10 CFR 50.90  
Docket No. 50-443  
SBK-L-17202

Seabrook Station  
Response to Seabrook Station, Unit No.1 – Supplemental Information Needed for Acceptance of  
Requested Licensing Action Re: Amendment to Delete Operator Action and Request for  
Exemption

**ENCLOSURE TO SBK-L-17202**

FIGURE 1

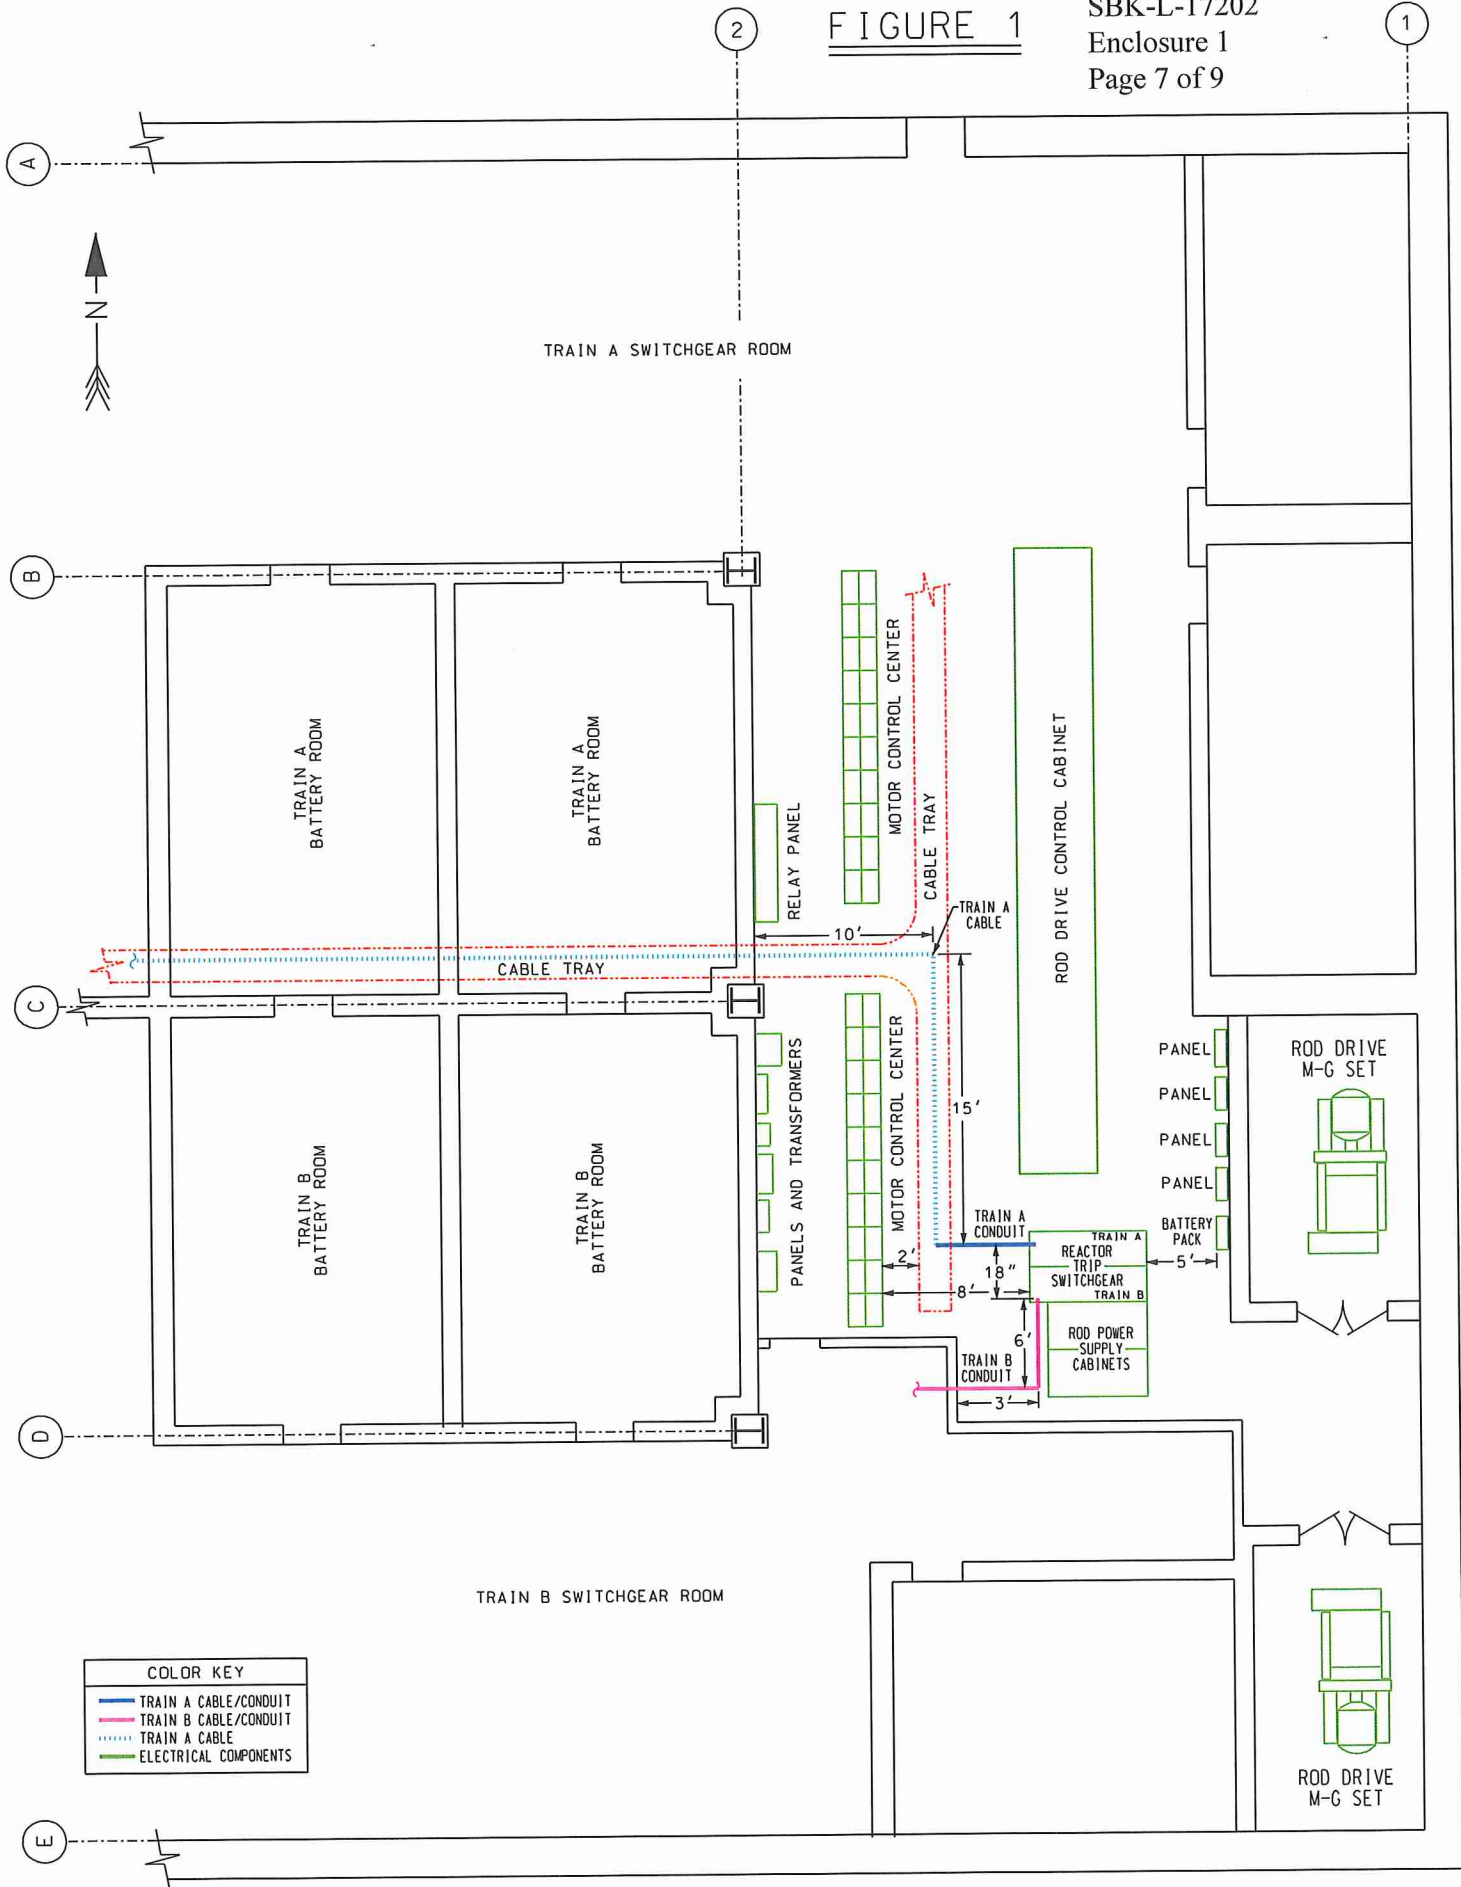
The staff noted that the submittal lacks a discussion of the routing of the shunt trip cables. A better understanding of the room layout, a description of the types of electrical cabinets, and their relationship to the target cabinets and cables is needed for the staff to make a safety determination regarding the lack of 20 feet of separation with intervening combustibles. The staff noted that the submittal also lacks information regarding the relationship between the two trains, and how close the cables are together both vertically and horizontally.

The train A and train B reactor trip breakers are located in adjacent cubicles in the train A switchgear room with the train A breakers north of the train B breakers. The train B switchgear room is located directly south of the train A switchgear room, separated by a 3-hour fire barrier.

The train A shunt trip cables are routed in conduit into a train A cable tray above the reactor trip switchgear train A cabinet about 4 ft. vertical and then 6 ft. west. The cables are routed north in the tray approximately 15 ft. before turning west approximately 10 ft. and over the train A vital battery rooms. The cables continue in the train A cable tray system vertical into the cable spreading room on the control building 50 ft. elevation. The train B shunt trip cables are routed in conduit vertical out of the top of the reactor trip switchgear train B cabinet approximately 20 ft. and then turn south approximately 6 ft. to the wall. The cables then turn west approximately 3 ft. into the train B switchgear room.

The minimum separation distance between the train A and train B cables is approximately 18 inches out of the reactor trip switchgear cabinets for approximately 4 ft. At that point, the train A cables are routed west into the cable tray, and the train B cables continue vertical. There is an Appendix R light battery pack and motor control center, as well as, the transformers and panels described in the TECH1 response in the vicinity of the train A and train B shunt trip cables. The motor control center is approximately 8 ft. from the reactor trip switchgear cabinets. The train B

conduit is approximately 6 ft. horizontal from the train A cable tray out of the top of the reactor trip switchgear cabinet. There are no intervening combustibles between the train A and train B conduits. The train B reactor trip switchgear is located very close to the train B switchgear room (Fire Area CB-F-1B-A), and the train B cable is routed only a short distance in the train A switchgear room as described in the previous paragraph.

The train A cables routed in cable tray in this area are not routed directly above any 480V or 4.16 kV electrical cabinets, and are maintained approximately 4 ft. vertical and 2 ft. horizontal from the nearby motor control center. The train B cables are in a dedicated conduit not routed over any high energy cabinets other than the reactor trip switchgear.

See Figure 1 on the following page for cable routing and equipment layout diagram.
